2 Scope and Purpose of Review

JBA Consulting (JBA) was appointed by the Fossil Free East Yorkshire (YWT) in September 2021, to advise on hydrological matters in connection to the application by Rathlin Energy Ltd, at the West Newton Exploration Well Site (Planning Application 21/02464/STFUL).

This document takes the form of a preliminary review of the application, the scope of which is to:

Figure 4-1: LIDAR in 0.5m Bands

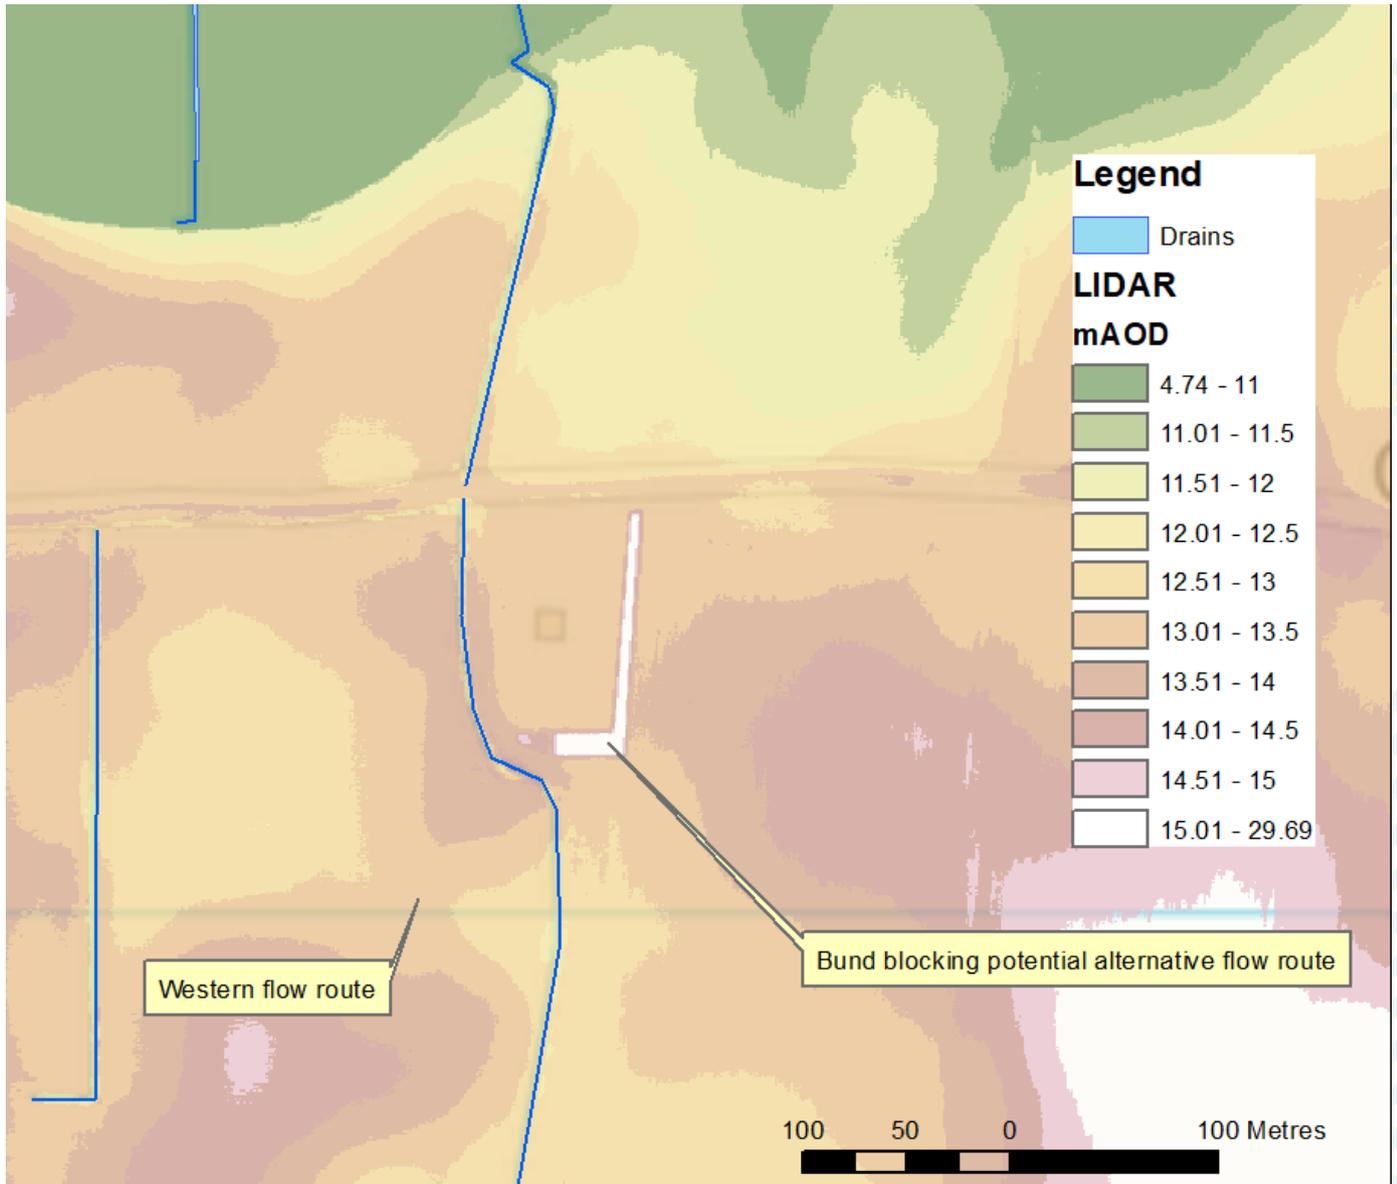
Regardless of the conclusions of Section 11.2.3, it is not clear from the new digital terrain model data (Environment Agency LIDAR) that the site is not subject to surface water flood risk. Figure 1 below presents a reclassification of the same LIDAR data presented in 0.5m height bands (compared to the 1m bands in the HFRA). It shows that when there is a flood event that would overwhelm the local drain, flow is likely to come out of bank and flow over the "Western Flow Route" as inferred in the HFRA. However, the LIDAR shows that the

bund around the current well pad may be blocking an alternative route through the site. This in effect means that the current bund acts as a flood defence deflecting water away from the site. No evidence has been submitted to show that the bund was designed for this purpose and therefore may not be designed to cope with this.

The issue could be resolved through the development of a surface water flood model using the updated LIDAR and additional topographical information on the drainage network. Until then, the risk to the site from surface water flooding has not been properly assessed. If the site is at risk of surface water flooding, or reliant on the current bund, additional mitigation would be required.
